Project Name: Nightcrawler Datacenter NLH

Submission No: 949

Description: NLH6 Replacement Panel Submittal

Submittal No: NLH6_230000_Panel Replacement

JOB			
JC Bowman Source Blue			
P.O.		CUST.	
CONTR		CRAWFORD ELECTRIC SUPPLYCOMPANY LLC	
TIE		CONSULT	
BY		ENG. LOC.	
DATE		DESIGNATION	
7-22-2026		1DHA.HDP.H02.2	
DWG. NO.			
everhx01c_07222601_00_00_M00-20000-1			
APP.		MFG. LOC.	
APP.		DWG. FILE	
SHEET 1 OF 6		REV.	
1		1

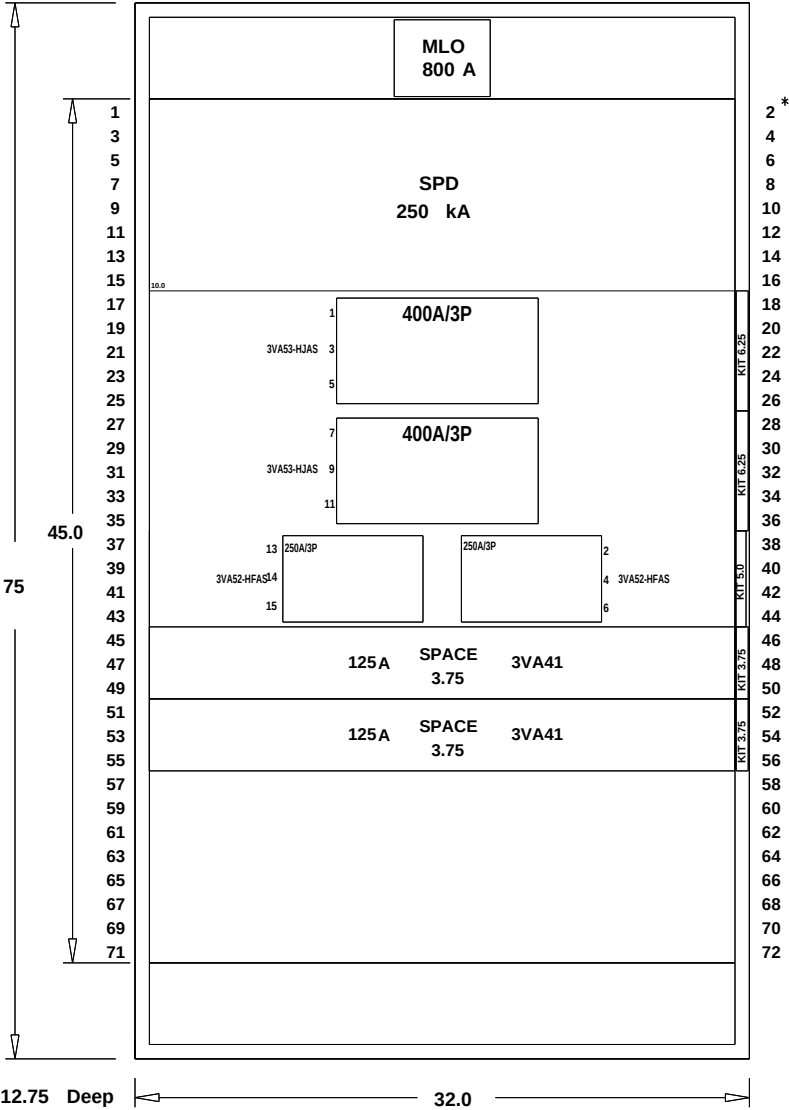
- *Panel HDP.H02.2 must be equipped with electronic trip breakers for main and all branch breakers. ETU 550 or 560 preferred*
- *Panel DP.H01-2 must be equipped with electronic trip main breaker. ETU 550 or 560 preferred. 100A branch breakers are preferred as electronic trip, ETU 350 or better, but is not required.*

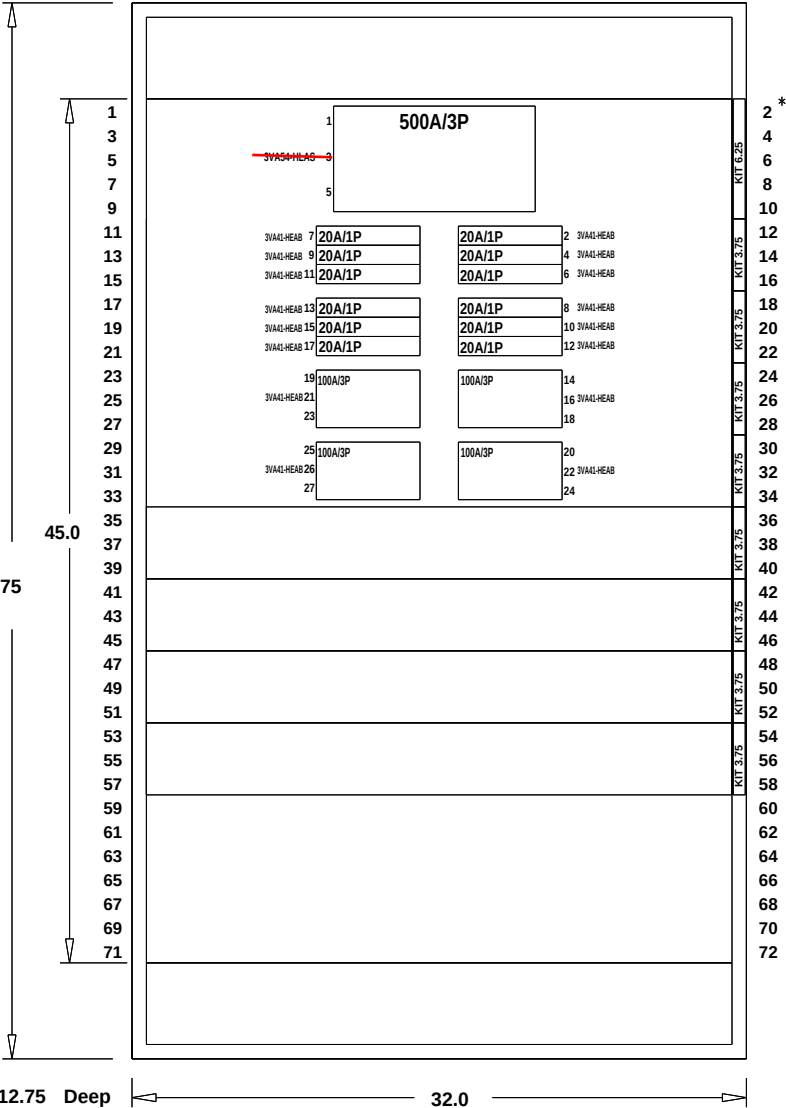
Main :
~~1 - 600A MAINBREAKER~~ 3P-3VA64 ETU 550 65 KAIC
1-(2)3/0-500KCMIL

BRANCHES :
12 - 20A /1P-3VA41-HEAB
1-3VA Mechanical (1)#14-#8 AL/Cu Lug
4 - 100A /3P-3VA41-HEAB ← RECOMMEND 3VA61 ETU 350 OR 550, 65 KAIC
1-3VA Mechanical (1)#14-3/0 AL / CU Lug
4 - 3P-3VA41-HEAB - SPACE
